**SMALLFORD WORKS**

**PINS Ref: APP/B/1930/W/20/3260479**

**PROOF OF EVIDENCE OF KARL PITMAN ON DRAINAGE  
MATTERS**

**on behalf of the Appellant, Stackbourne Ltd**

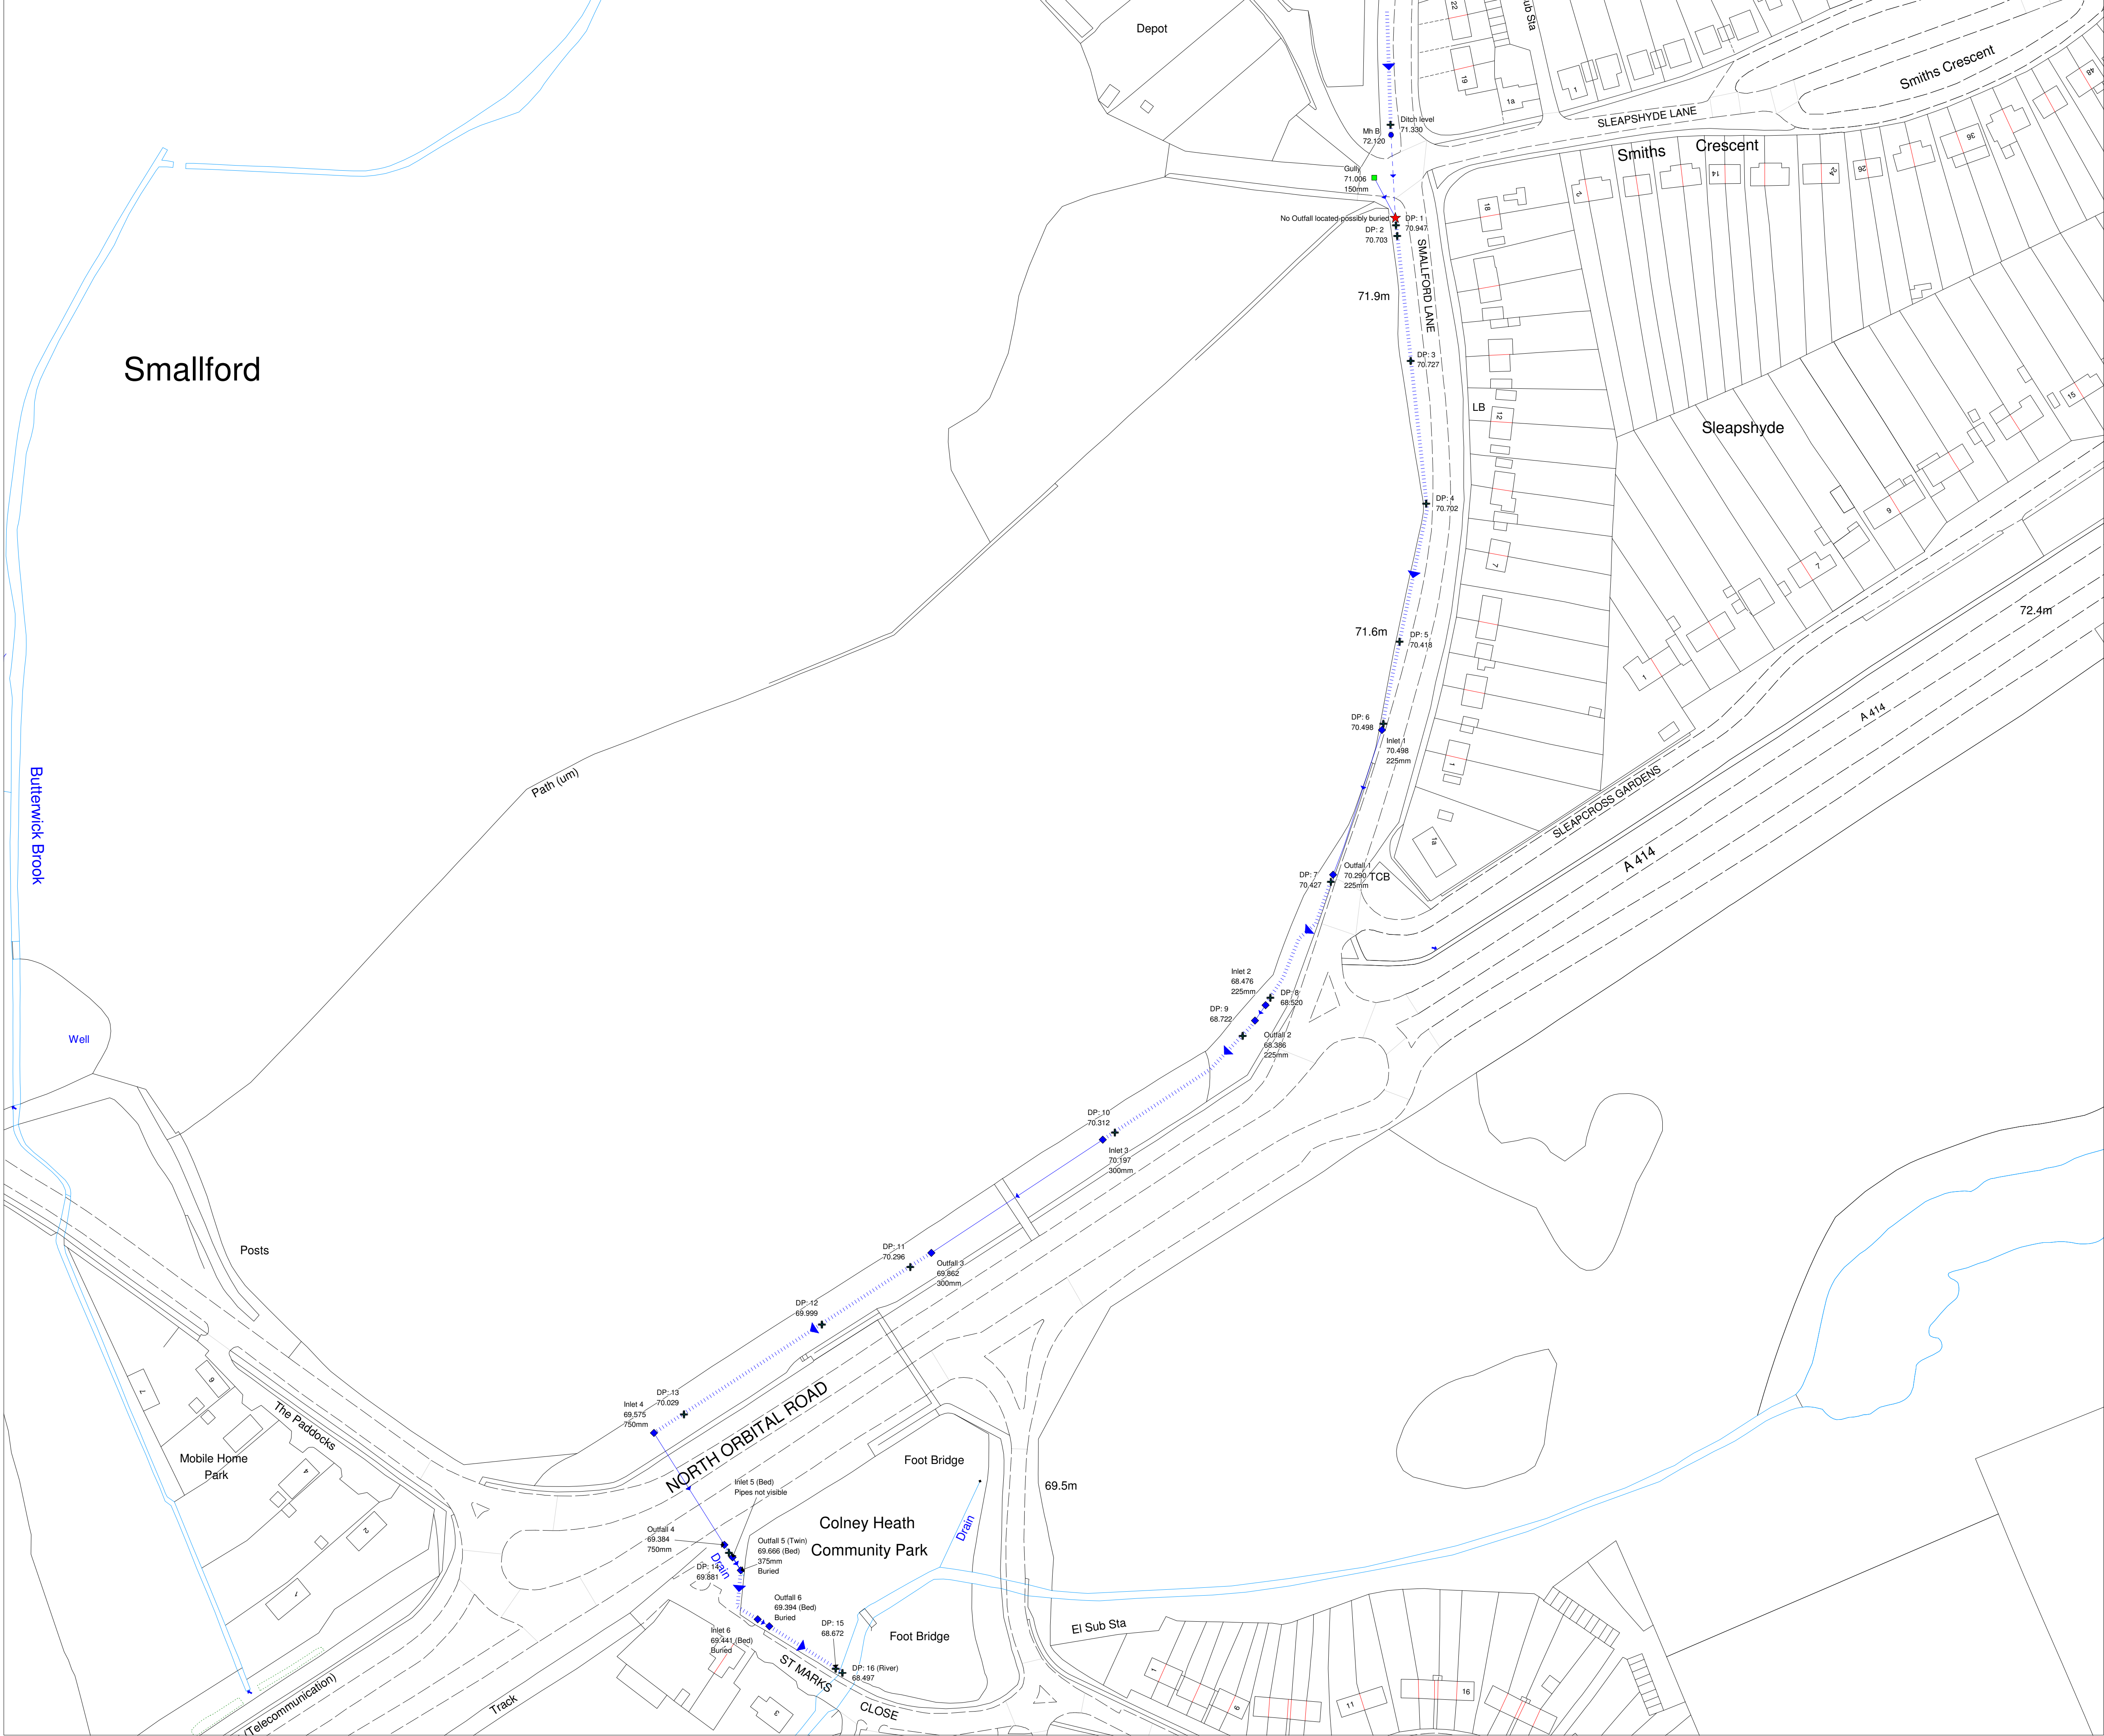
1. **Identification of a suitable discharge mechanism:** The LLFA letter states that they *"visited the site on the 12<sup>th</sup> August 2020 and investigated the stream on the eastern site boundary. At present we are of the view that this ditch has no onward connection to any existing watercourse and serves only as a highway ditch to manage road run-off"*. The letter goes on to state that *"it should be noted that agreement from the owner of the ditch would still be required for a modified connection from any surface water management system for the site"*.

2. **Clarification of any connectivity from the identified ditch to an existing ordinary watercourse or main river:** The latest LLFA letter states that *"there is no visible outfall from the (eastern boundary) ditch, it is not clear where the water goes once the proposed development discharges here. In order to ascertain that this is a suitable discharge location for the development we require evidence to confirm a visible connection from the ditch to a watercourse...."*.

11. Additional information on drainage was submitted to the LLFA on 19<sup>th</sup> January 2021 in the form of a drainage survey of the ditch along the eastern site boundary (refer to Appendix C). This additional information

demonstrates that this ditch is connected to the River Colne (which is designated by the Environment Agency as a main river). The point at which the ditch connects to the main river is immediately north of St Marks Close after the ditch is culverted under the North Orbital Road. This therefore provides the necessary clarification regarding the connectivity of the ditch to a main river.

14. The drainage survey submitted on 19<sup>th</sup> January 2021 proves that the ditch along the site's eastern boundary connects to the River Colne to the south of the application site and therefore connectivity has been demonstrated.

15. We note that some remedial works are required to provide appropriate structures for the existing outfalls to the ditch. We also note that modifications (including the possible removal of screens) to the inlets to the culverts are required to complete the works approved under application 5/02/2112. We do not consider these an impediment to delivery of a suitable sustainable drainage system to serve the proposed development.
